# NORTHEAST UTILITIES

A09447

Millstone Nuclear Power Station, Unit No. 2  
RI-91-A-0036

MILLSTONE NUCLEAR POWER STATION, UNIT NO. 2  
RI-91-A-0036  
RM-8123A/B - SKETCH #1

Sketch #1

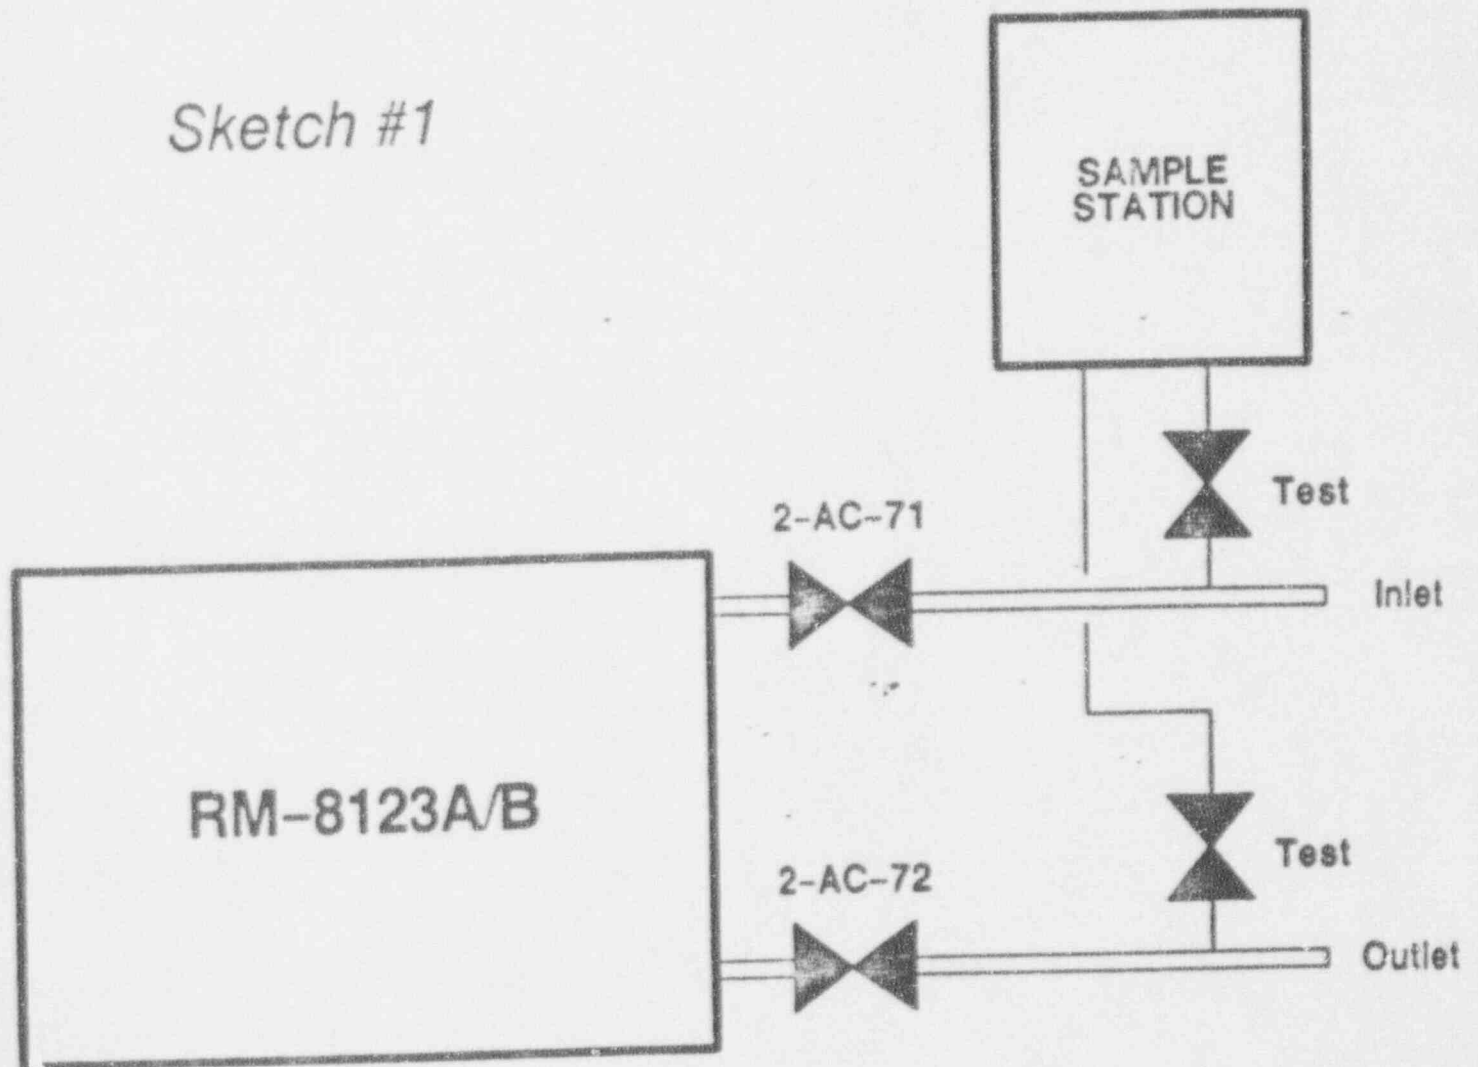
On February 6, 1991, a Health Physics Technician sampled the containment air by both grab sample and at the inlet to radiation monitor RM-8123A/B. The samples resulted in about 50 cpm at the radiation monitor and 2300 cpm from the grab sample. The radiation monitor may have been isolated from the containment. Recently, the hydrogen monitor was determined to be isolated from the containment as documented in plant incident report, PIR 91-16.

Please discuss the operability of radiation monitor RM-8123A/B on February 6, 1991. Was there a procedural problem that caused the two samples to differ? Please discuss the possibility of a valve control problem discussed in the PIR and [whether it] may have caused the sampling problem. If any weaknesses in either procedural compliance or valve control are determined, please discuss actions that you have taken or will take to correct the problem.

The sample station located next to RM-8123A/B takes a sample by tapping off of the lines that supply the RM-8123A/B skid. The sample is taken in parallel with the RM-8123A/B skid (see Attachment 1, Sketch #1).

Based on our review of this configuration, there is no operability, procedural, or valve control problem associated with RM-8123A/B.

The discrepancy between the samples is most likely due to the sample station being partially or totally isolated when the sample in question was taken. A review of the RM-8123A/B strip chart for the February 6, 1991 date in question indicates that RM-8123A/B was not isolated. The gaseous and particulate count rates on the strip chart were representative of the expected values and did not show any deviation that would have been experienced if RM-8123A/B had been isolated. RM-8123A/B was functioning properly during this period. There is no relationship between this issue and the event addressed by PIR 91-16.
